# Groundwater Transfer Review Summary Form

Transfer/PA # T- 14168

Application: T-14168

Applicant Name: City of Malin

## Transfer Review Map

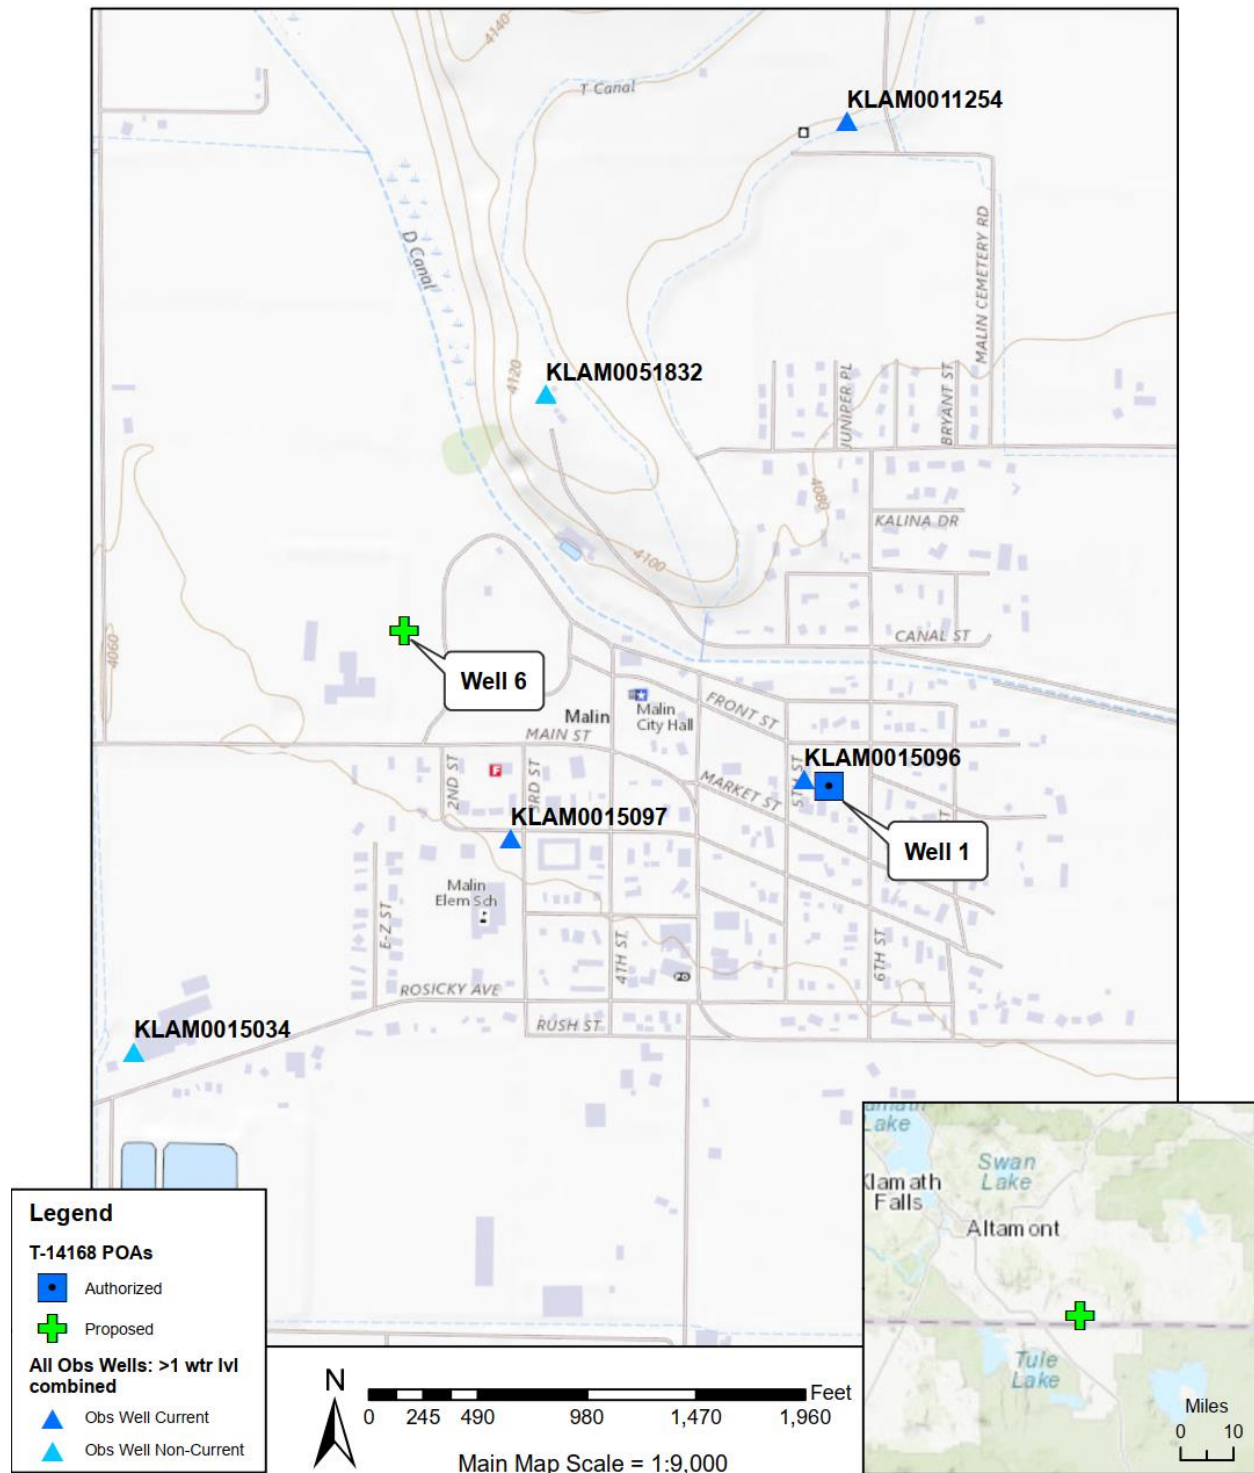
1. Basic description of the changes proposed in this transfer: The applicant proposes to change point of appropriate associated with Groundwater Claim **GR 4060** from the authorized POA **KLAM 15096** (which was abandoned under **KLAM 53047**) to proposed POA “**Well #6**”. The applicant also proposes to change the POU to match the City of Malin’s urban growth boundary.

2. Will the proposed POA develop the same aquifer (source) as the existing authorized POA?  
☒ Yes ☐ No Comments: Despite difference between the reported completed depth of authorized POA **KLAM 15096** of 380 feet below land surface with the proposed depth of 820 feet below land surface of proposed POA Well #6, both wells will source water from tertiary aged basalts at depth.

4. a) Will this proposed change, at its maximum allowed rate of use, likely result in an increase in interference with **another ground water right**?  
☒ Yes ☐ No Comments: The proposed change would move the POA closer to **KLAM 15034** (0.42 miles vs 0.63 miles), an authorized POA under **Certificate 92366** and would likely increase the amount of hydraulic interference with that right.

☐ Yes ☒ No If yes, explain: Wells that are reasonably efficient and fully penetrate the aquifer are not likely to be injured by this transfer due to the thickness of the aquifer and generally-high transmissivity. It should be noted that the Groundwater Claim that this transfer proposes to modify, GR 4060, has a priority date of 1931 making it senior to most of the groundwater rights in the area.

☐ Yes ☒ No Comments: The closest hydraulically connected surface water source for the Tule Lake Valley is the Tule Lake Sump located in California. The proposed change is not expected to substantially change the impacts to nearby surface water sources.
